**JOINT REGIONAL PLANNING PANEL
(Sydney East Region)**

JRPP No	2014SYE067
DA Number	DA167/14
Local Government Area	North Sydney Council
Proposed Development	Construction of a new mixed use building
Street Address	7-19 Albany Street, St Leonards
Applicant/Owner	Austino St Leonards Pty Ltd
Number of Submissions	3
Regional Development Criteria (Schedule 4A of the Act)	CIV over \$20 million
List of All Relevant s79C(1)(a) Matters	<ul style="list-style-type: none">• Environmental Planning Instruments:<ul style="list-style-type: none">North Sydney LEP 2013SEPP55 – Remediation of LandSEPP65 – Design Quality of Residential Flat DevelopmentSREP (2005) – Sydney Harbour Catchment• Draft Environmental Planning Instruments: Nil• North Sydney Development Control Plan 2013• Voluntary Planning Agreement – Attached
List all documents submitted with this report for the panel's consideration	<ol style="list-style-type: none">1) Plans and Elevations2) Voluntary Planning Agreement

Recommendation	Approval
Report by	Lara Huckstepp, Executive Planner

Assessment Report and Recommendation Cover Sheet

Additional Notes: Solar Access to 34 Oxley Street, St Leonards

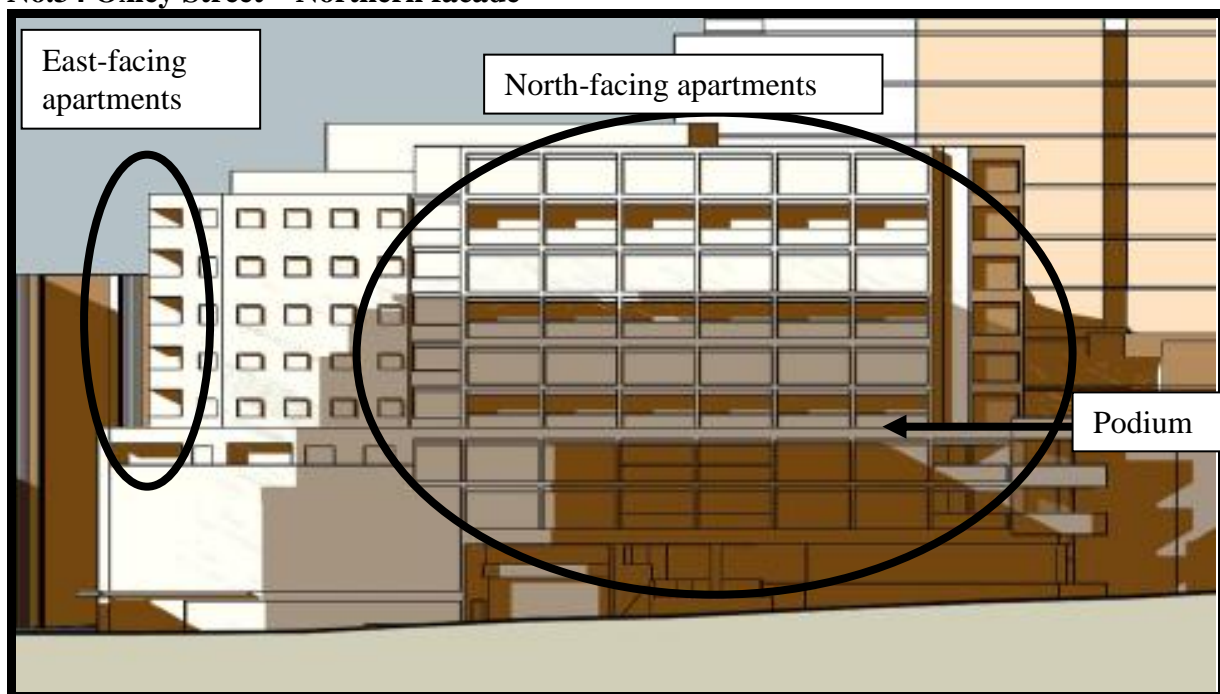
North Facing Apartments below podium – A total of 11 single level apartments are located below the podium level over Levels 1 & 2. These apartments will be overshadowed such that they receive no direct sunlight between 9am – 3pm during the midwinter solstice.

North Facing Apartments above podium – A total of 18 north-facing apartments are located above the podium level. Of these apartments 13 will receive 2 hours of sunlight between 9am – 3pm during the midwinter solstice. Of the remaining 5 apartments during midwinter between 9am – 3pm:

Conclusion for impacts to 34 Oxley Street – The apartments within No.34 Oxley Street presently receive solar access to their northern facades over the existing generally under-developed subject site, considered to be essentially borrowed amenity. The proposed development has been designed to maximise solar access to these apartments, and on balance, the level of solar access received by the proposed development is considered to be acceptable. The proposed impacts are an expected outcome of the site dictated by the planning controls and is supported in this regard.

Proposed additional shadow on Hume Park shown in green at 3pm midwinter

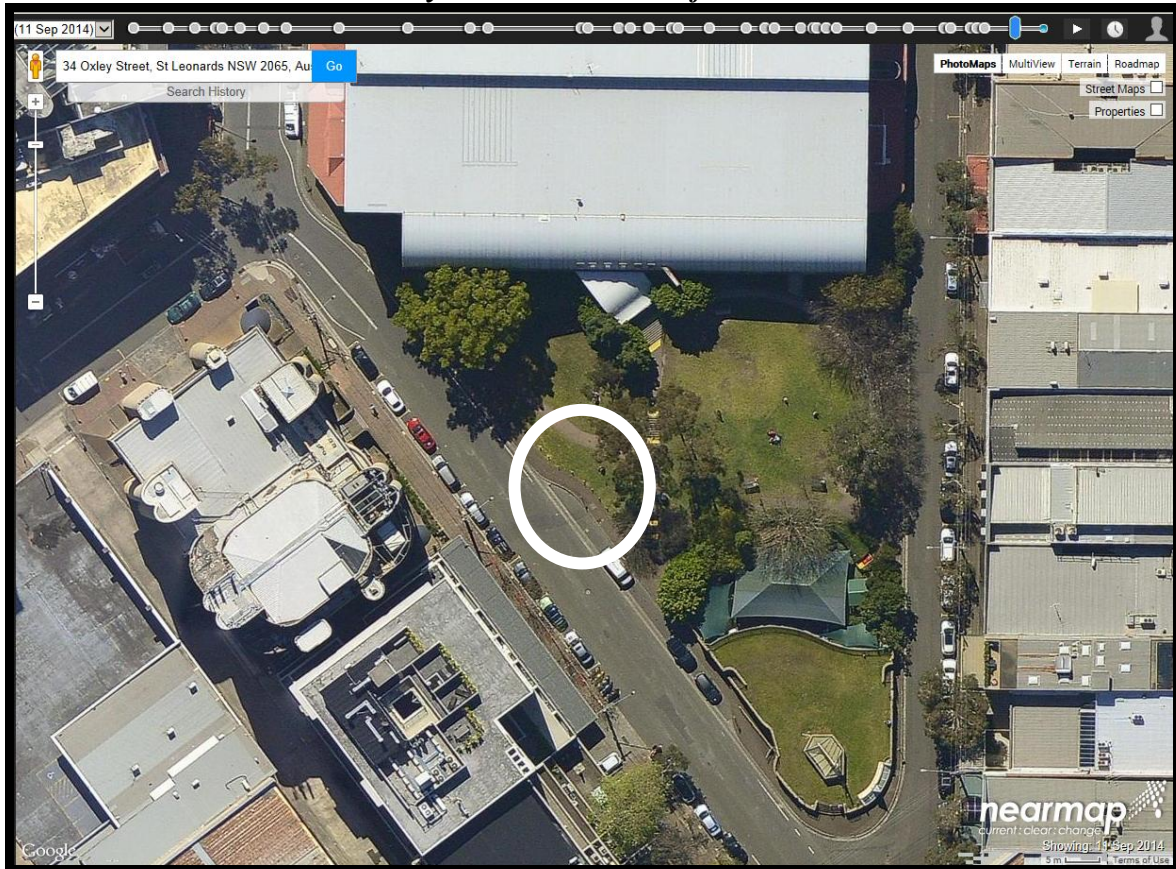
DCP Section 2.3.7 P4 requires that *‘New development should not overshadow existing or proposed public open spaces located outside of the North Sydney Centre between 11.30am and 2.30pm’*.

The submitted shadow diagrams detail that the proposed building results in a minor increase in overshadowing to the road reserve / grass area adjacent to the footpath within Hume Park between 2pm and 3pm. The overshadowing does not occur within the primary useable area of the park, and infills generally an existing slot located between existing overshadowed areas. Longer term plans will see the park form part of a link to the east to Willoughby Road and this will address this minor loss of solar access.

On balance, the overshadowing is considered to be minor, and given the location of the overshadowing being adjacent to the roadway, is not considered to reduce the useability or material provision of solar access to the space and will comply with the intent of Objective O1 Section 2.3.7 which requires that:

Photo taken from upper level apartment within No.40-48 Atchison Street looking south-east (taken during Planning Proposal assessment)

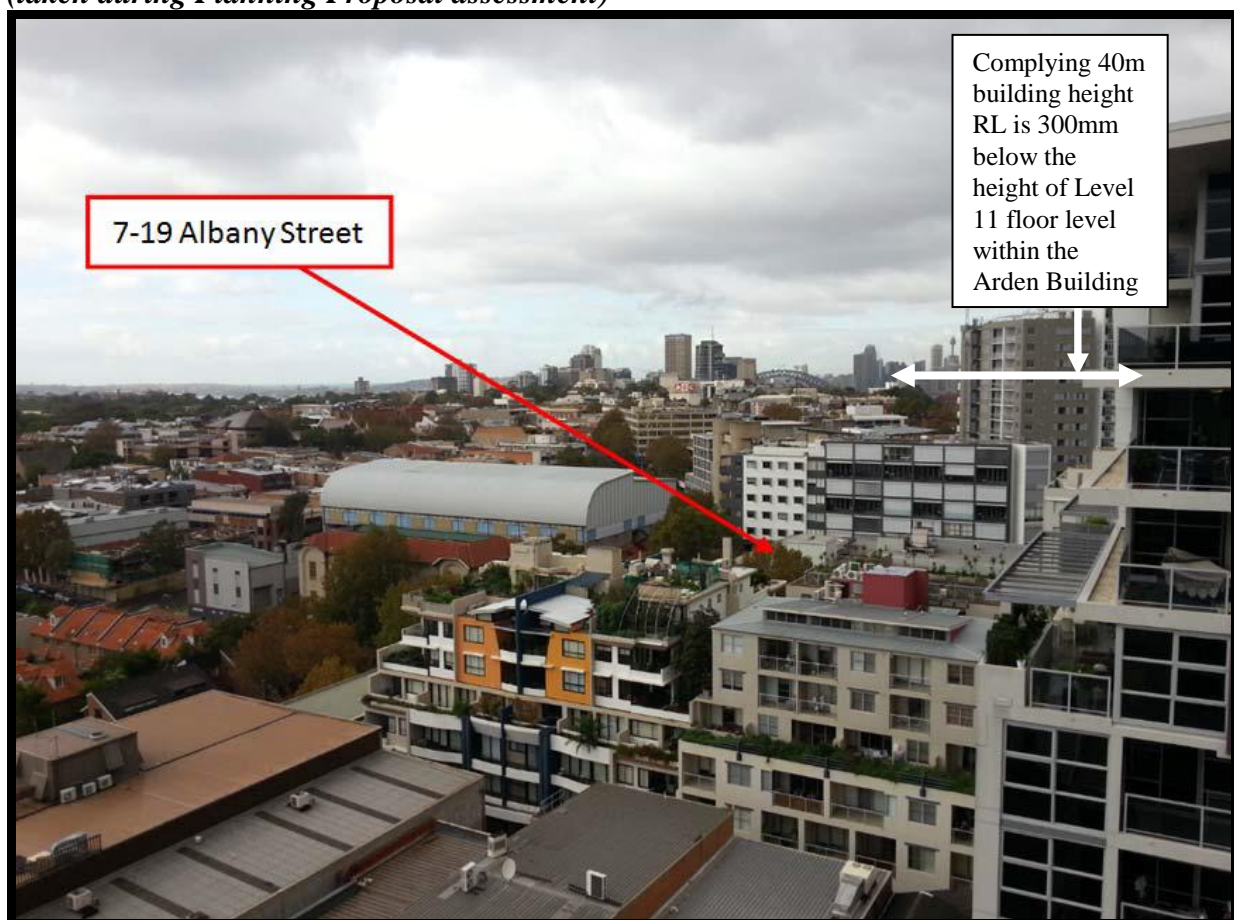
An indicative view taken from the upper level of an apartment within No.40-48 Atchison Street during the assessment of the planning proposal is seen below to demonstrate the outlook presently enjoyed across the site by a number of properties:

The LEP building height limit for above-mentioned buildings at the Nexus, Arden and the Abode buildings is 40m. (Note: it is noted that the Abode has been constructed at 60m). As such, with comparable LEP building heights to the height that is now applicable to the subject site, retention of views, particularly distant views to the harbour, harbour bridge and city being over 3km away, is considered to be an unrealistic expectation to retain in the circumstances.

The view impacts have been considered at the Planning Proposal stage whereby a 40m LEP building height was considered to be reasonable and subsequently imposed on the site. The proposal represents a generally acceptable level of compliance with the building height limit, with a building height breach at the eastern building end of approximately 1.6m serving the residential level, and the height exceedance of the plant at 2.4m. Given the generally consistent height of buildings (with the exception of the Abode Building), the views are generally removed by those components that comply with the 40m height limit. Any remaining view toward the city of structures above the 40m building height is considered to be negligible, and this horizon strip view would be unlikely to be easily read over the top of the building. The quality of the view is substantially reduced by complying building elements.

Proposed North Elevation

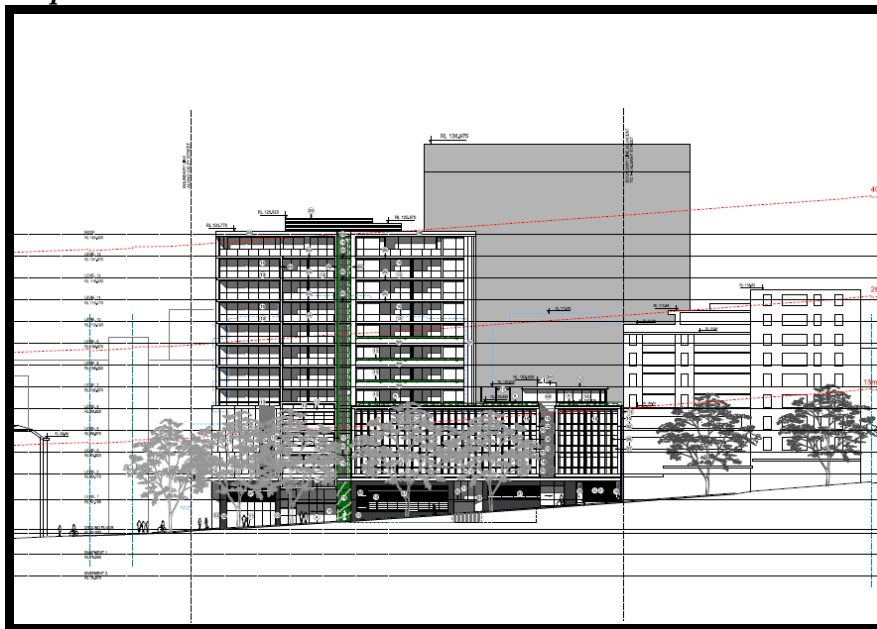
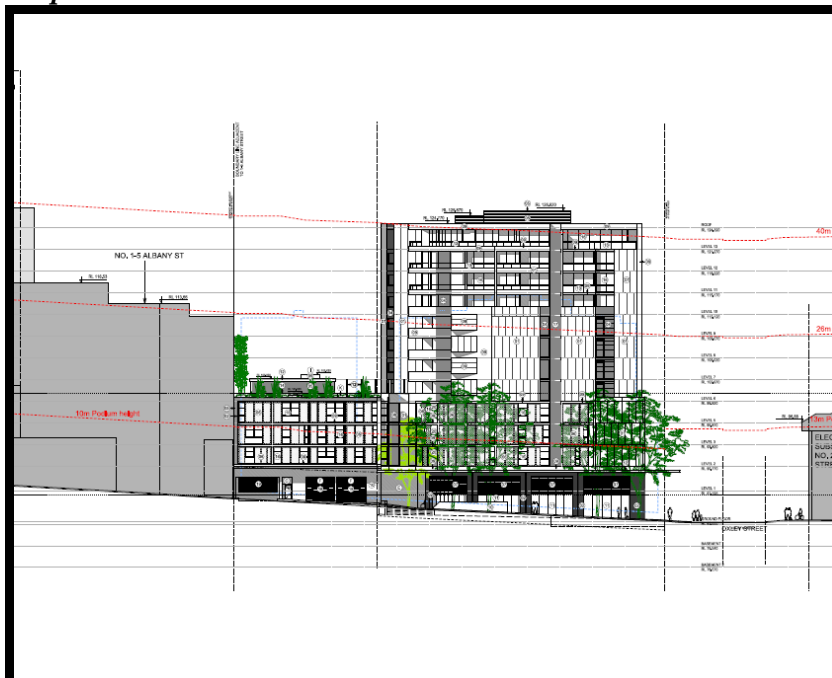
Clause 4.3 NSLEP 2013 sets a maximum building height on the site of 40m. The proposed development results in an overall building height of 41.57m. The height of the residential level (Level 8) has a maximum height ranging between 39m – 41.57m. A height of 42.8m is proposed over the roof plant.

Clause 4.3(2C) LEP 2013 sets out that Development Consent must not be granted to development within 'Land in St Leonards' wherein the proposes breaches the building height control by greater than 3m (excluding plant rooms and other similar structures). The subject site is not within the area of St Leonards wherein this restriction applies, however notwithstanding this, It is noted that the proposed breach of the building height control would have a maximum non-compliance of 1.57m at the eastern end, excluding the plant and would therefore comply with this principle.

It is concluded that the applicant's objection pursuant to Clause 4.6 is reasonable and the breach of the building height control can be supported in this instance. While strict compliance could be achieved this would not have a material benefit to outlook, amenities or views enjoyed by private or public places.
